**TAMARACK  
CONCEPT PLAN**

TAMARACK  
 4/1 HOMES OF INDIANA, LP  
 CONCEPT PLAN  
 161st Street & Oak Road, Union City, Indiana  
 DATE: 05.01.2015

TAMARACK  
 4/1 HOMES OF INDIANA, LP  
 CONCEPT PLAN  
 161st Street & Oak Road, Union City, Indiana  
 DATE: 06.24.2015

**Tamarack Enhancements**  
**(post June 1 Plan Commission)**  
**(Updated June 25, 2015)**

**Original Concept Plan (05.01.2015)**

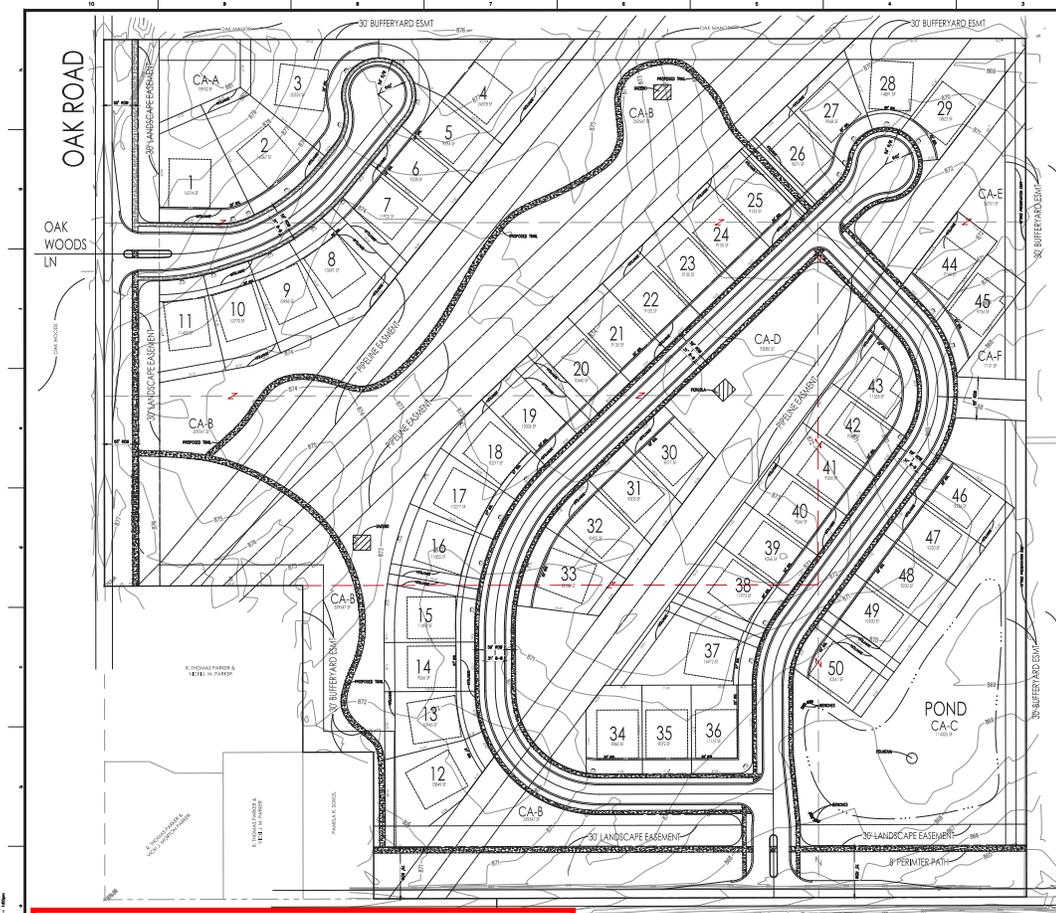
**LOTS:**  
 Number of Lots = 50  
 Density = 1.45 Lots / Acre  
 Typical Lot Size = 70x135'

**PROPOSED SETBACKS:**  
 Front Setback = 22' MIN.  
 Rear Setback = 25'  
 Sideyard Setback = 5'

**OPEN SPACE CALCULATIONS:**  
 Overall Site = 34.4 Ac  
 Open Space Outside Pipeline Easements = 8.14 Ac  
 Pipeline Easement Area = 6.32 Ac  
 Total Open Space Provided = 14.46 Ac  
 Total Percentage Provided = 42.0 %

1. The Concept Plan was updated to reflect revisions to the land plan.
  - A. Entrance location moved east along 161<sup>st</sup> Street,
  - B. Provided loop street and reduction of cul-de-sacs,
  - C. Provided frontage road with fronts of homes facing 161<sup>st</sup> Street.
  - D. Further enhanced lot sizes adjacent to adjoining Oak Manor lots,
  - E. Reduced the number of lots by three, and
  - F. Provided additional landscaping and mounding in multiple locations.

**(Concept Plan)**

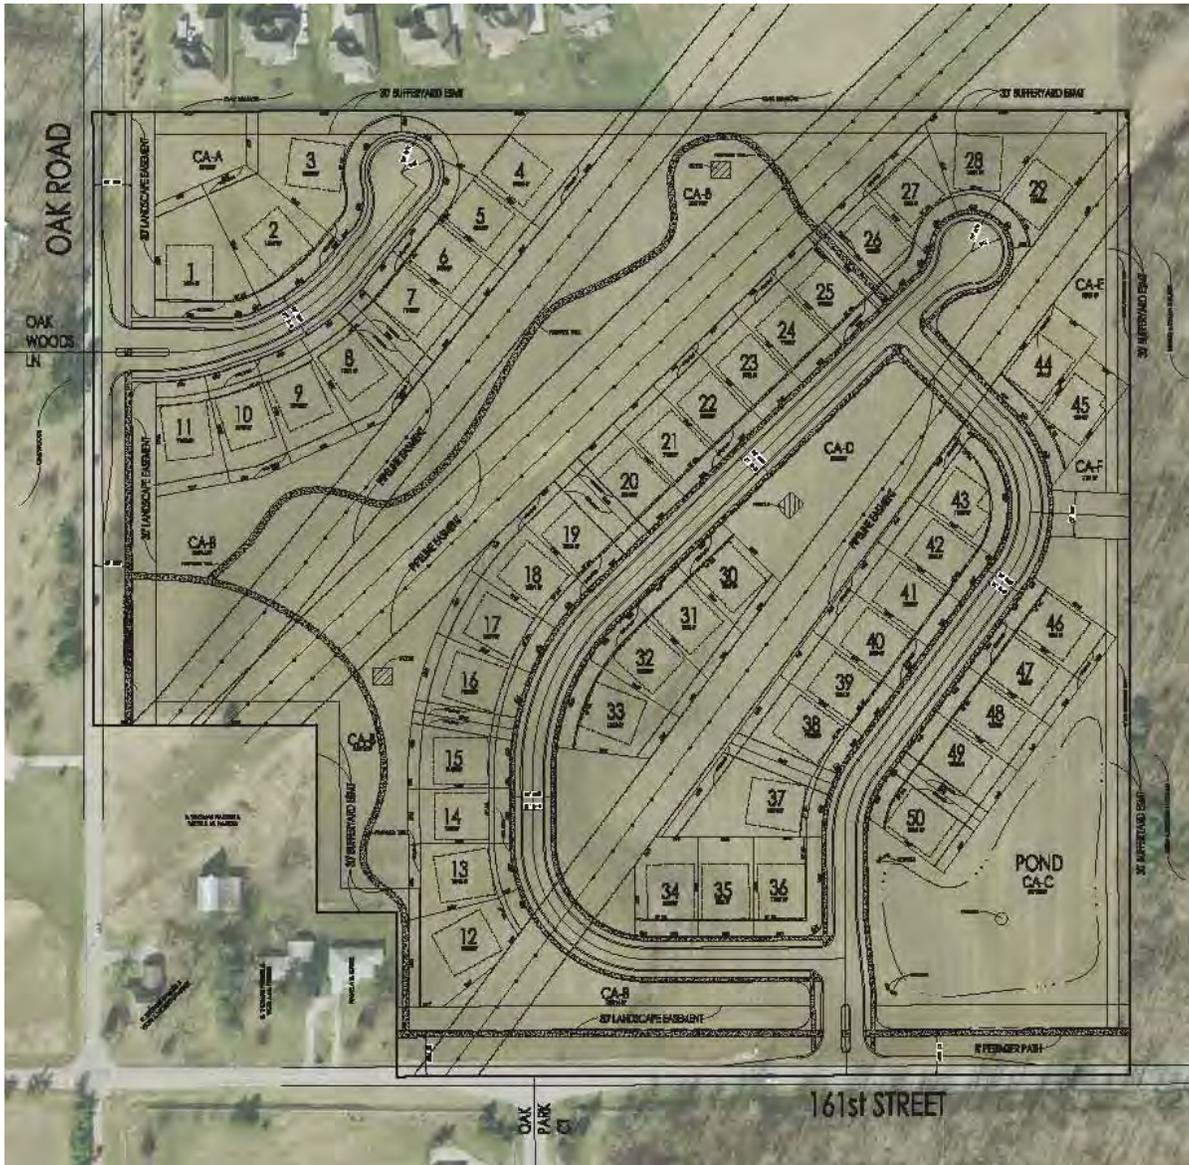
5. Shade and Evergreen trees shall be planted within the common area northwest of Lot 20 thru Lot 27 as generally shown on the Concept Plan. The minimum number of trees planted in this area shall be calculated at one (1) tree per fifteen (15) feet of lot frontage along the rear of Lot 20 thru Lot 27.

6. An undulating mound (approximately 3-5 feet in height), with a minimum height of three (3) feet, shall be installed along the north perimeter of Common Area A, Lot 3 and Lot 4 as shown on the Concept Plan. Evergreen trees shall be planted along the mound at a rate of one evergreen tree per fifteen (15) feet along the north perimeter of said Common Area and Lots.

7. An undulating mound (approximately 3-5 feet in height), with a minimum height of three (3) feet, shall be installed along the east perimeter of Common Area E (outside the pipeline easement) and Common Area F as shown on the Concept Plan. Evergreen trees shall be planted along the mound at a rate of one evergreen tree per fifteen (15) feet along the length of the mounds.

8. A fifteen (15) foot wide tree preservation area will be provided along the east perimeter of the Real Estate as shown on the Concept Plan.

Exchange for updated color concept plan

Page 7 of 9

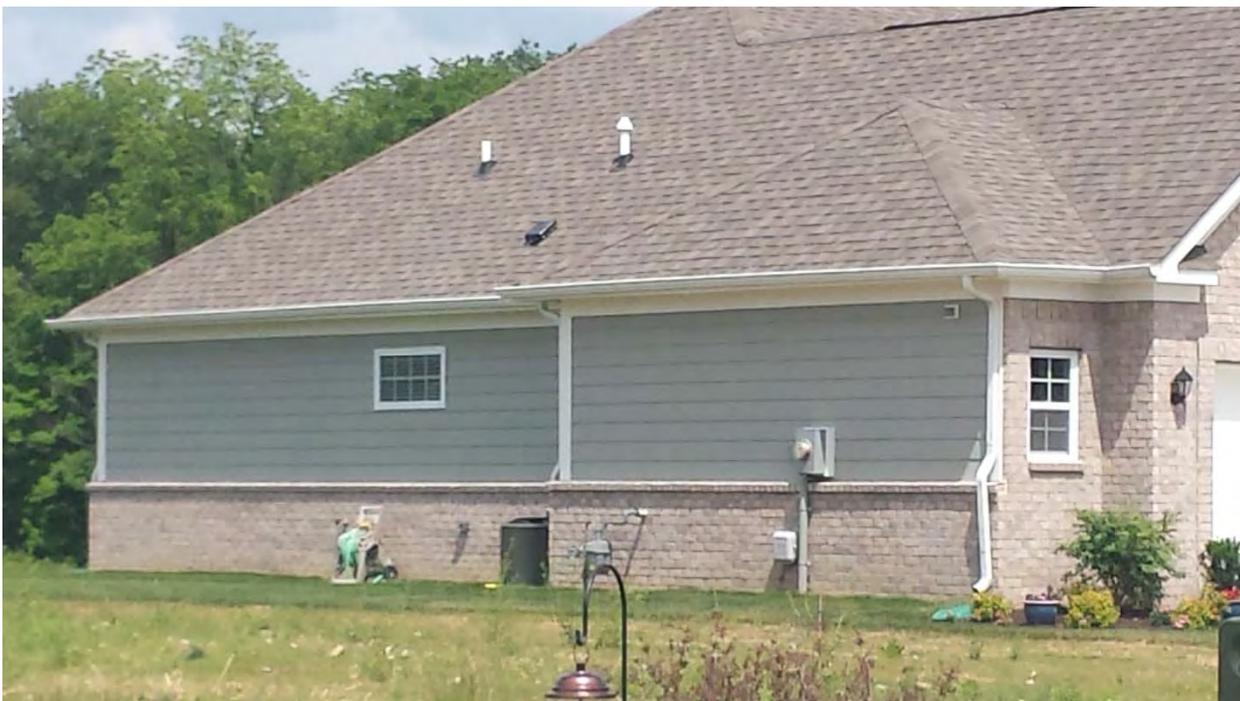
- iv. **A minimum thirty-six (36) inch masonry wainscot (measured from the Dwelling foundation) shall be the exterior building material on the side and rear façade of all Dwellings as generally illustrated on Page 7 of 9 and Page 8 of 9 of the Character Exhibit. This provision does not limit the use of additional masonry on the rear and side facades.**
